A D D E N D U M

Project: EACS HS Classroom Renovations

Addendum No: 02

Date: 12-18-2024

Architectural Demolition Plan - Second Floor

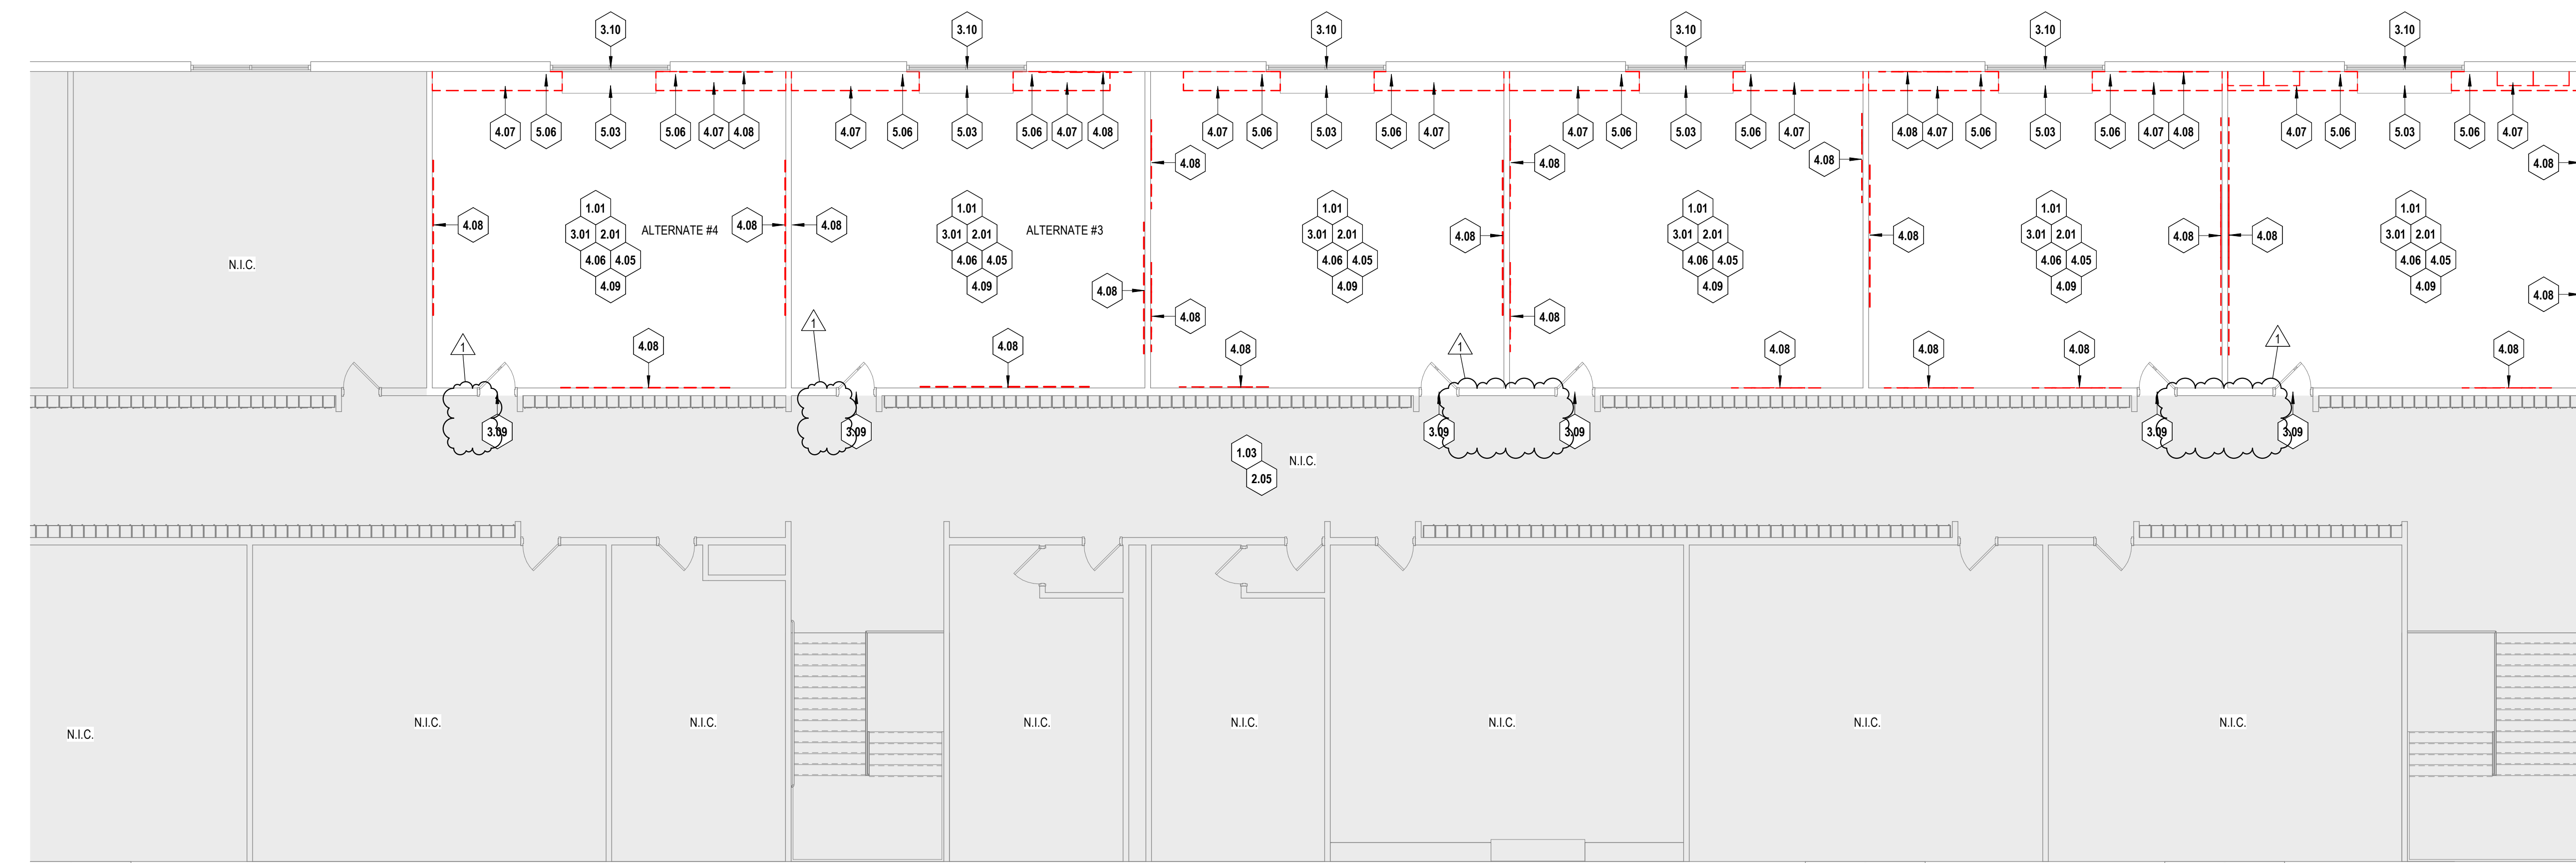
ITEM NO. 2.01 - DRAWING NO. AD101 Architectural Demolition Plan – Second Floor

- A. Removal of Demolition Plan Notes 3.07 from Second Floor Architectural Demolition Plan.
- B. Removal of note 3.07 from Demolition Plan Notes.

Architectural Notation Plan - Second Floor

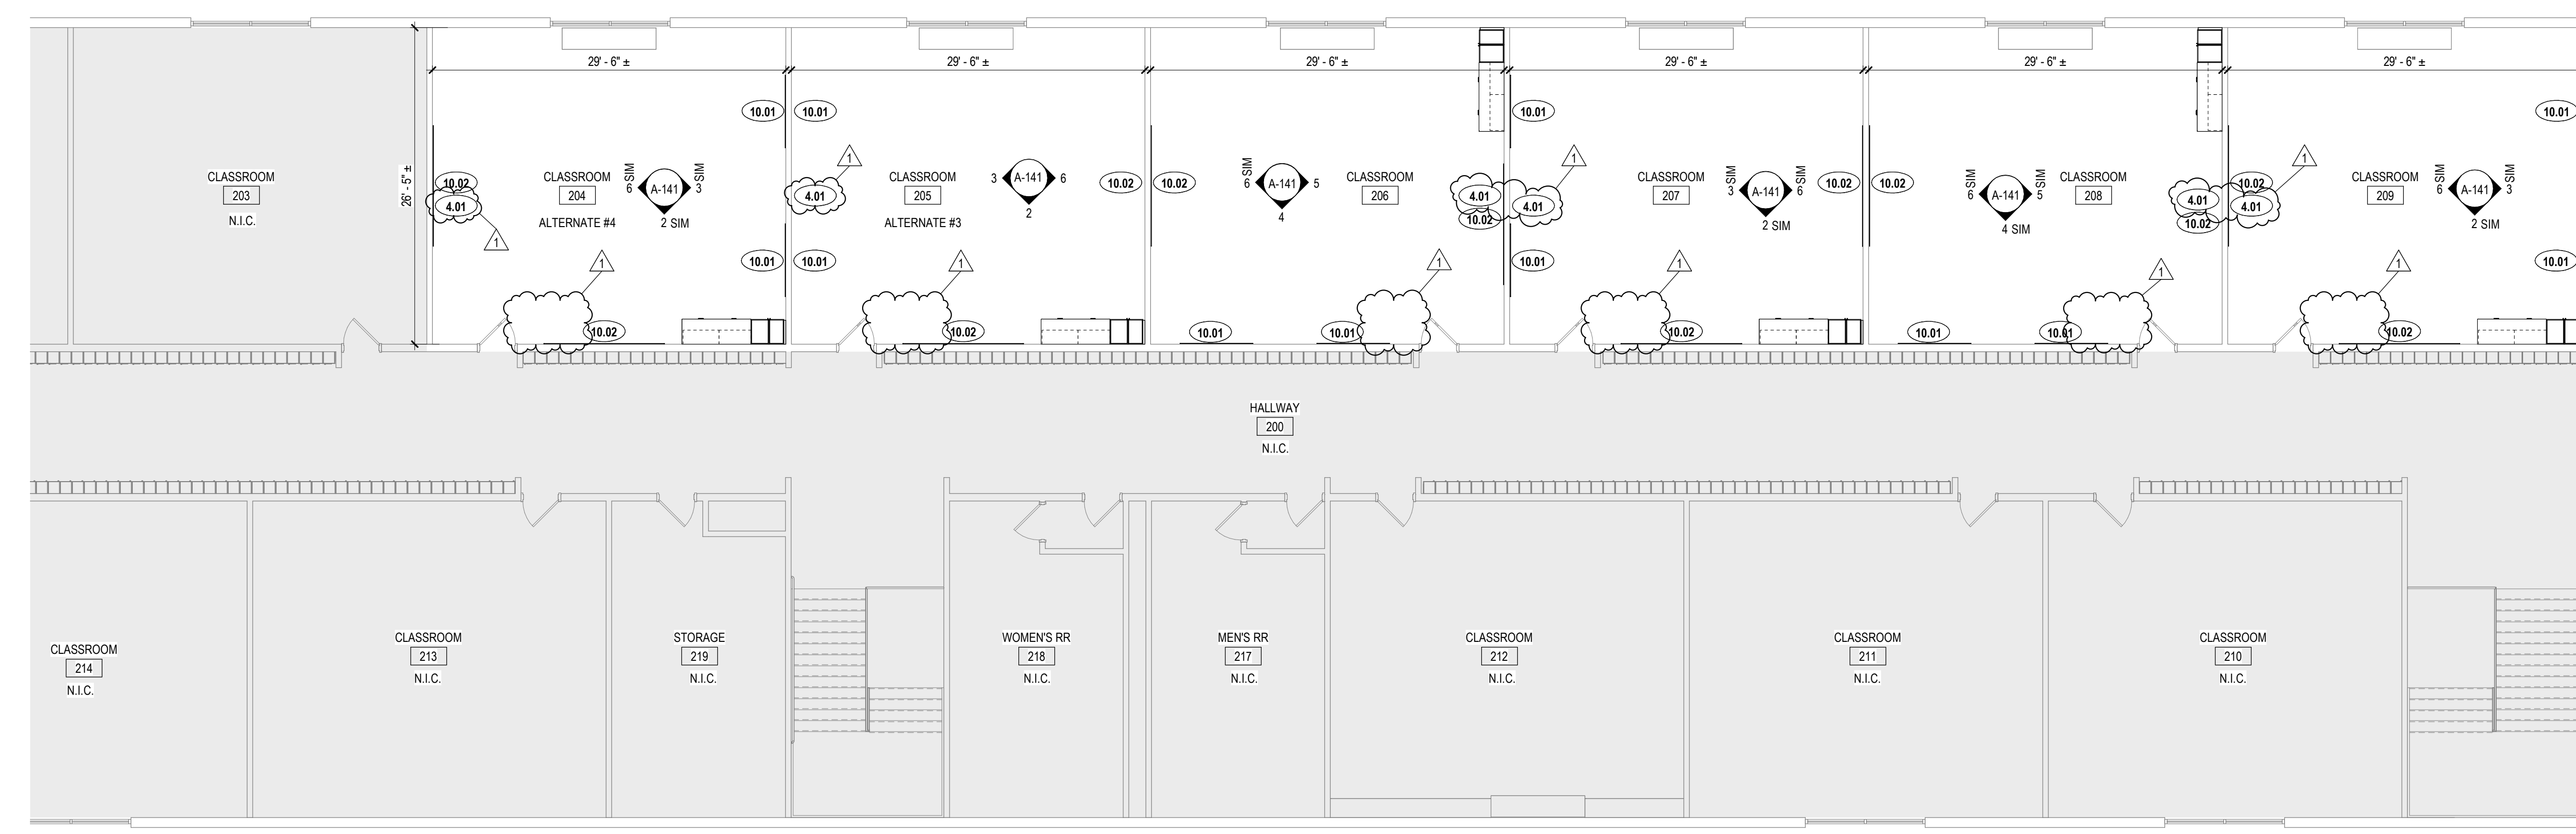
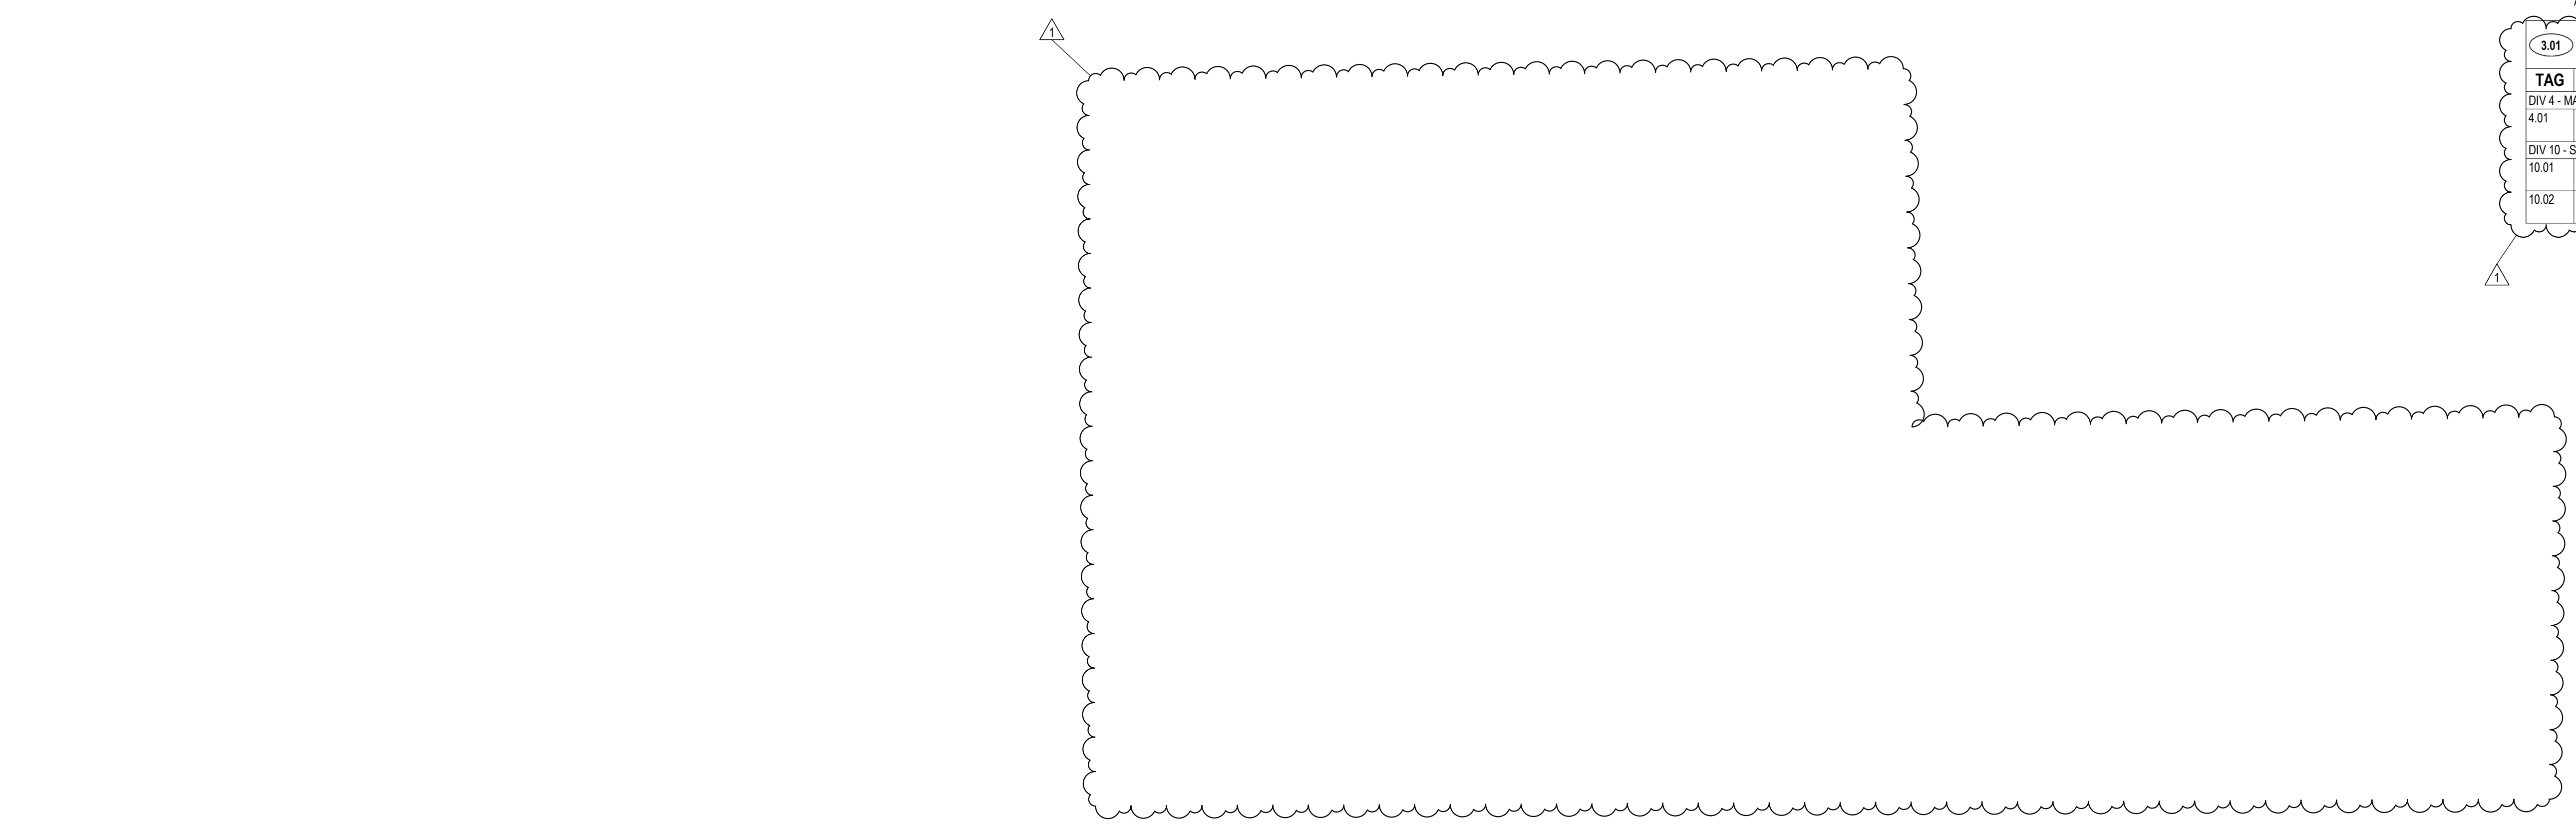
ITEM NO. 2.02 - DRAWING NO. A-111 Architectural Notation Plan – Second Floor

- C. Addition of Floor Plan Note 4.01 to rooms 204, 205, 206, 207, 208, 209.
- D. Addition of note 4.01 to Floor Plan Notes.
- E. Removal of Floor Plan Note 9.01 from Second Floor Architectural Notation Plan
- F. Removal of note 9.01 from Floor Plan Notes.
- G. Removal of Door Elevation – Transom Infill #2.
- H. Removal HM Frame Transom Infill Detail #3.
